# City of Santa Fe, New Mexico

# memo

**2025-011550-HDRB, 539 Garcia St.,** Downtown & Eastside Historic District, contributing, Geisler Projects, agent for Matt and Penelope Rembe, owners, proposes to construct a 33 sq. ft. addition to a height of 10'-6" where the maximum allowable is 10'-10", a 309 sq. ft. portal to a height of 10'-3", and replace windows and doors on the residence, convert the garage to a casita by altering the garage door to a window, and installing a new window, and reroof, stucco, and paint both buildings. Exceptions are requested to section 14-5.2(D)(2)(d) for constructing an addition within 10' of the primary façade, and 14-5.2(E)(2)(b) for a window opening at less than 3' from the corner of a façade.

Figure 5: Façade Diagram

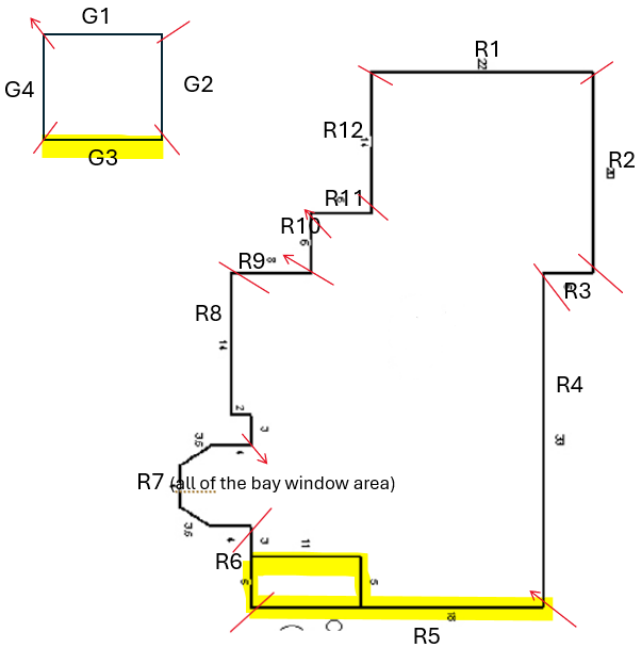
Staff Response: Staff finds that this criterion is not met. This does not focus on why the 10’ setback does not work on this project or why the smaller setback from the primary façade is necessary.

Staff Response: Staff finds that this criterion is not met. The hardship of having an addition at less than ten feet from the primary façade is not addressed.

Staff Response: Staff finds that this criterion is not met. No other designs are discussed, nor is there reasoning for this one design.

Staff Response: Staff finds that this criterion is not met. This is a new window installation on an addition, not a replacement of the window in the 1984 bay window addition.

Staff Response: Staff finds that this criterion is not met. No hardship is discussed, and again, this is a new window in a new addition, not a replacement.

Staff Response: Staff find that this criterion is not met. While the applicant's explanation for the smaller window on the south façade is valid, the larger window under the portal is too large and could be decreased in size to meet the requirement.
